Access Compliance Report Public Rights-of-Way (Curb Ramps)

Main Street: N/A Cross Street: ETHEREAL_RD Location: NW

ADA ID: RPRK211104123818 Ramp Type: Type 4 - Parallel Initial Pass/Fail: Fail Overall Compliance: No Severity Score: 2

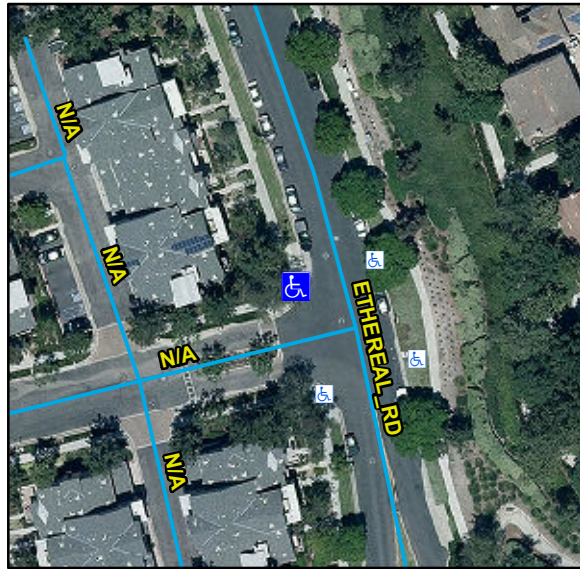
Compliance	Description	Data	Compliance	Description	Data
N/A	Ramp Length LT (in)	143	N/A	Ramp Length RT (in)	136
Yes	Ramp Width LT (in)	88	Yes	Ramp Width RT (in)	88
Yes	Ramp Run Slope LT (%)	1.6	Yes	Ramp Run Slope RT (%)	6.1
No	Ramp Cross Slope LT (%)	2.2	No	Ramp Cross Slope RT (%)	3.7
N/A	Landing Present	N/A	N/A	DWS Provided	N/A
N/A	Landing Length (in)	N/A	N/A	DWS Contrast	N/A
N/A	Landing Width (in)	N/A	N/A	DWS Length (in)	N/A
N/A	Landing Run Slope (%)	N/A	N/A	DWS Full Width	N/A
N/A	Landing Cross Slope (%)	N/A		DWS Offset Type	N/A
N/A	Landing Movement Obstructed?	N/A	N/A	DWS Offset Left (in)	N/A
	Landing Movement Type	N/A	N/A	DWS Offset Right (in)	N/A
N/A	Landing Shared	N/A			
N/A	Clear Space	Yes			
N/A	Clear Space To Crosswalk (in)	N/A			
N/A	Marked Crosswalk 1	No	N/A	Marked Crosswalk 2	No
	Crossing 1 Direction	S		Crossing 2 Direction	E
	Marked Crosswalk 1 Width (in)	N/A		Marked Crosswalk 2 Width (in)	N/A

Remove & Replace Curb Ramp With Two New Directional Ramps or Equivalent.

R204.3, R304.5.3, STD 1115
